CONTRACT ADDENDUM

ADDENDUM NO.: Three (3)

PROJECT NAME: Wyckoff WTP Clearwell #3

DATE ISSUED: June 25, 2020

2" COPPER PIPE & BALL VALVE DETAIL

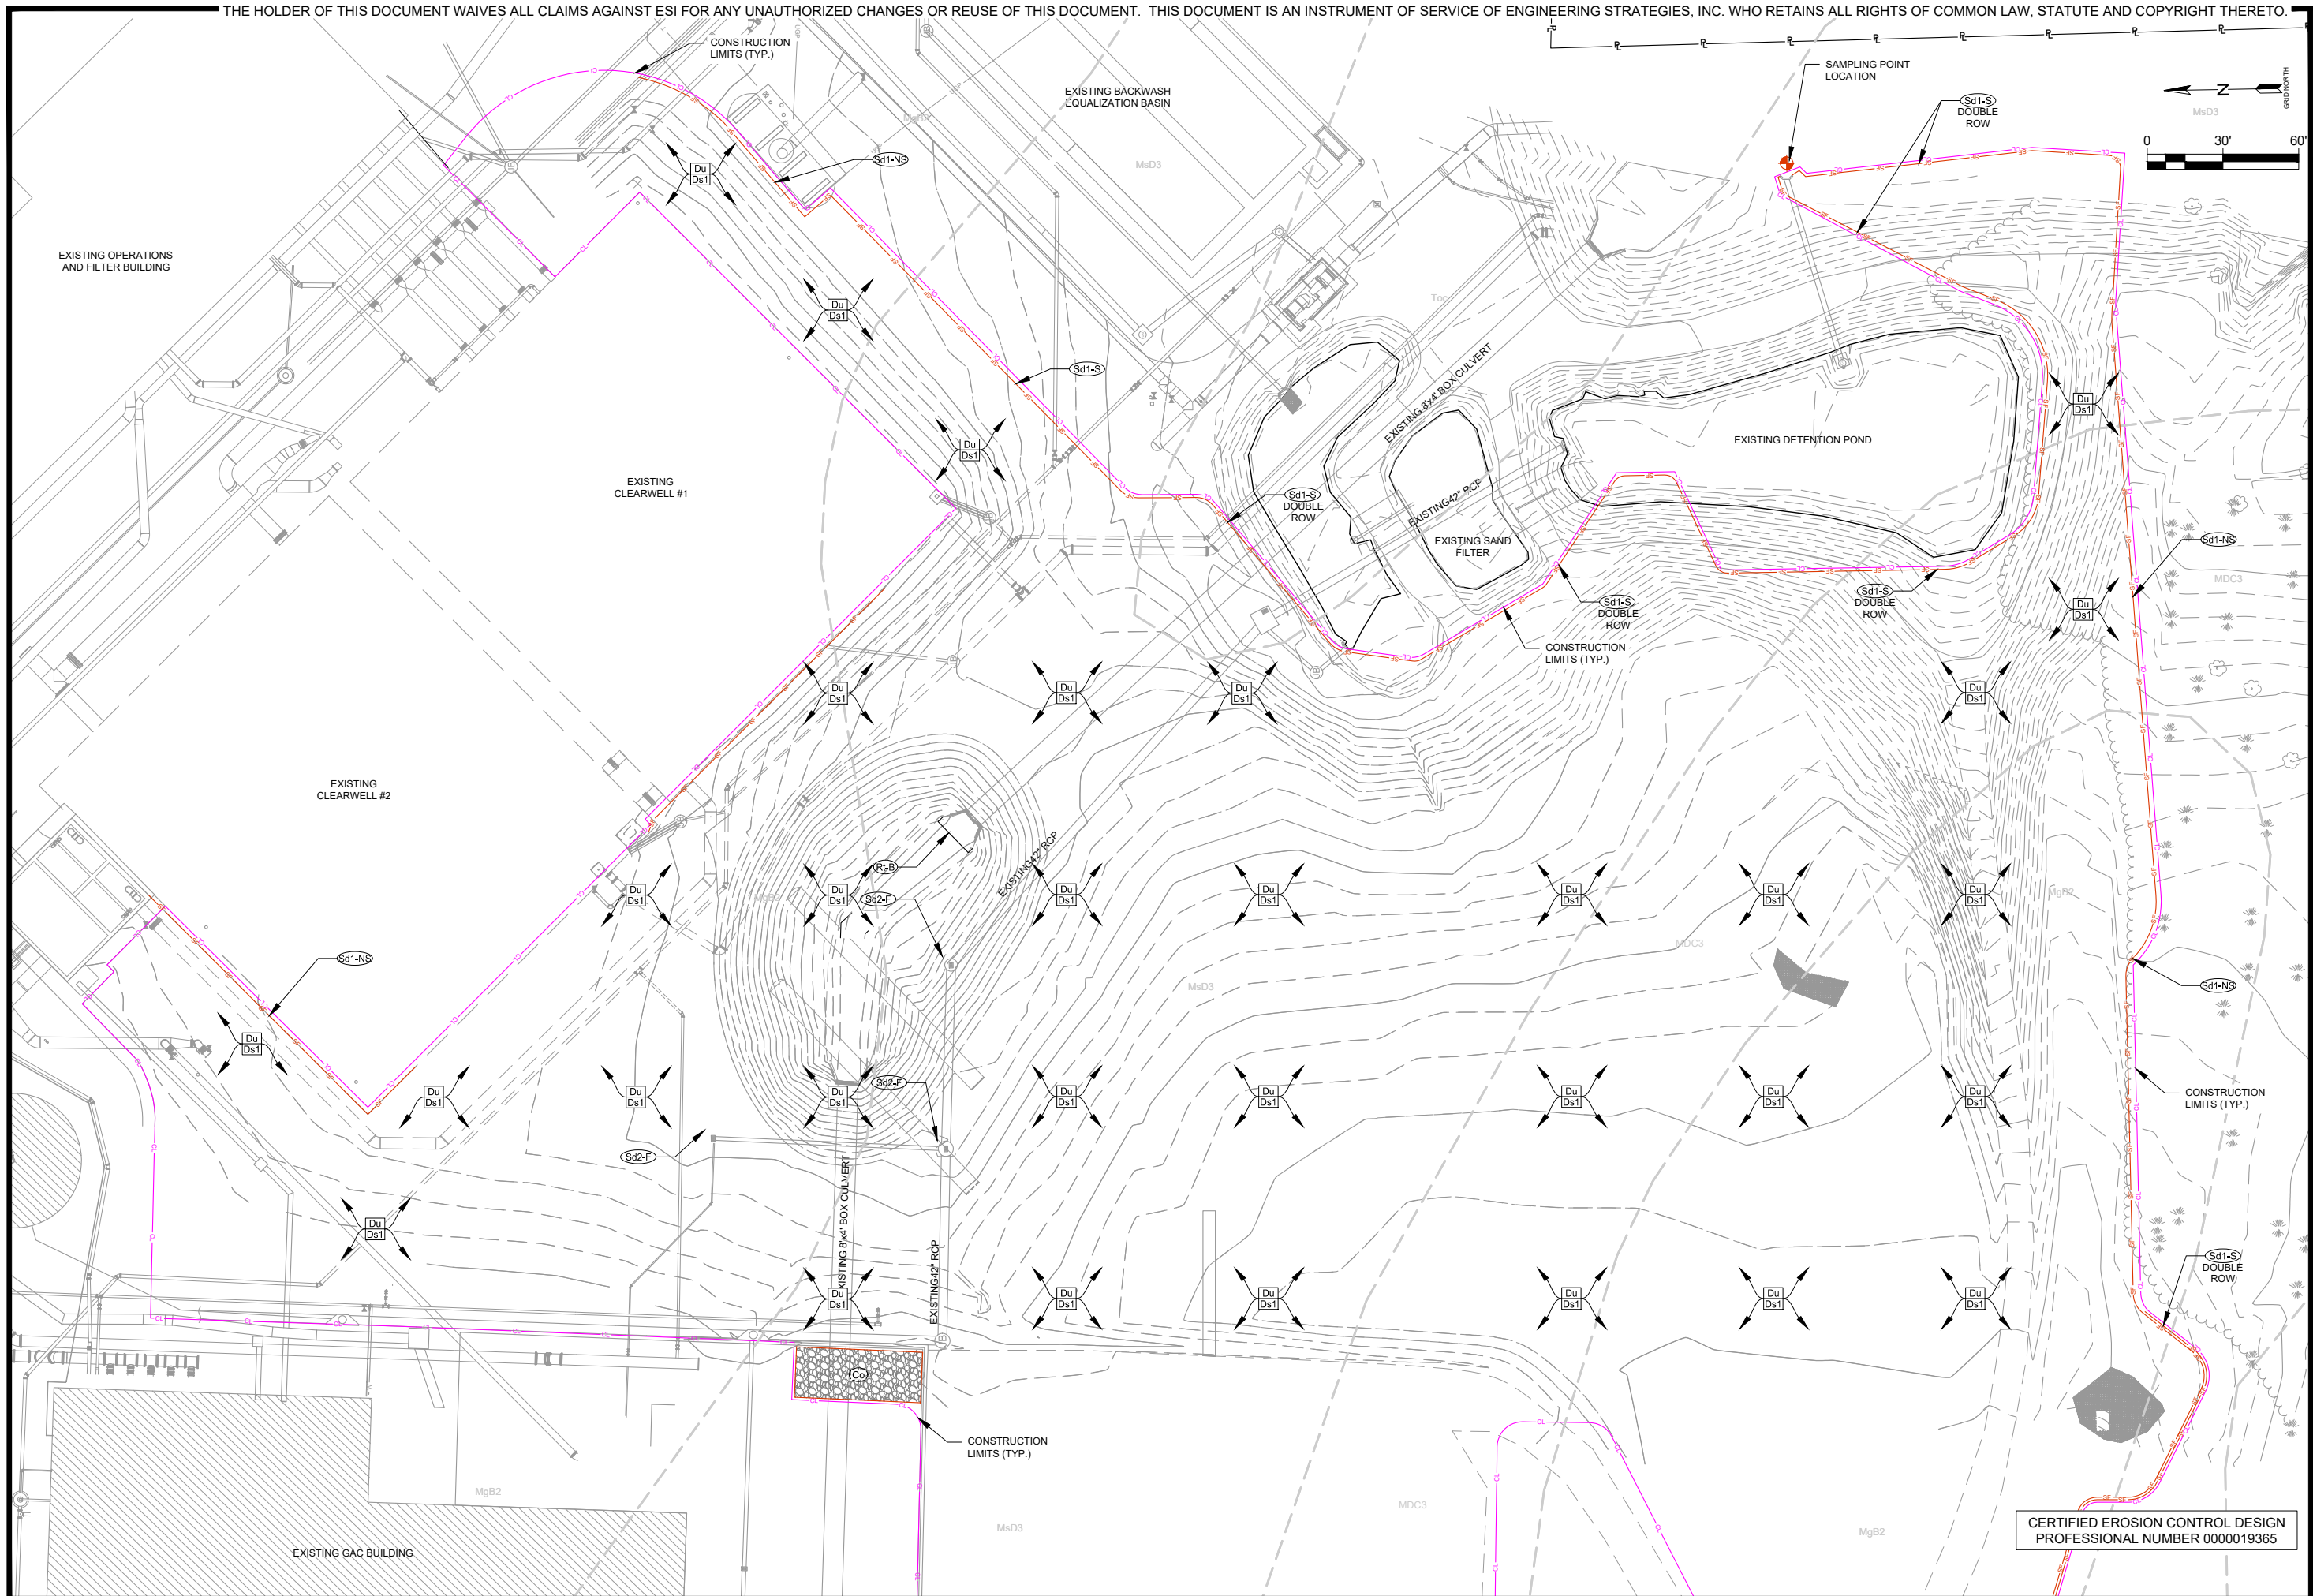
"Provide one portable hoist, Halliday Products Series Model D3B36E, and furnish and install four floor style sockets, Halliday Products Model D3S Lined, one at each hatch location."
3. Sheets ESC-1 through ESC-3: Replace with the drawings attached herein.
4. Sheet M-6: Add the attached detail for the 2" Copper Pipe and Ball Valve Detail for the 2" copper pipe on caps of 84" steel pipe shown on Sheet C-5.
